APPENDIX C: AREA WALK-BY CHECKLISTS (AWCs)

Area Walk-By Checklist (AWC)

Area 1AB-1a Floor El. 574 Bldg. AX

File Name: 1-60-2-1-18.jpeg
Description: View of toolbox in the area

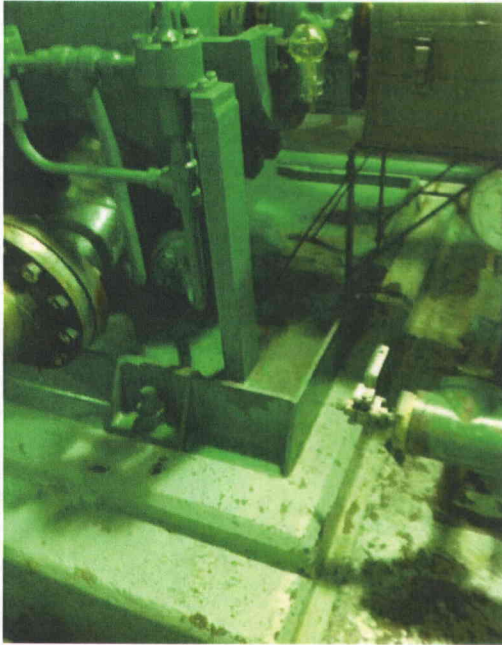
Toolbox identified in the area but located far away from components. Scaffolding identified to be adequately supported.

File Name: 1-70-3-1-20.jpeg
Description: View of corroded pipe in 1P46B001A

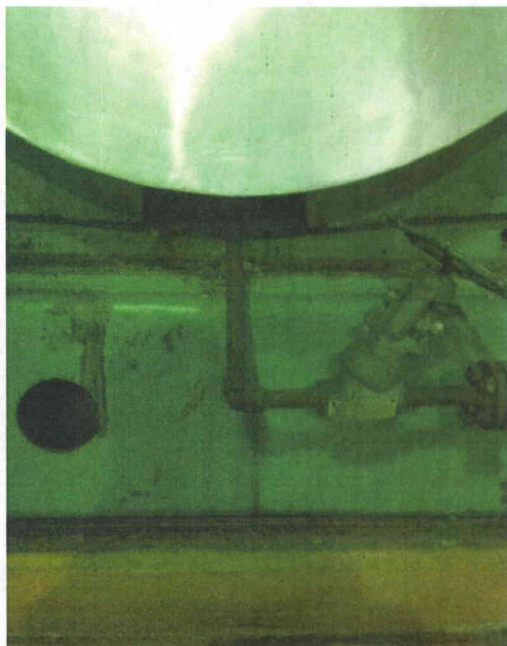
Anchorage for TB chillers identified with significant corrosion. This is judged to be acceptable, as described in comments for Question 1.
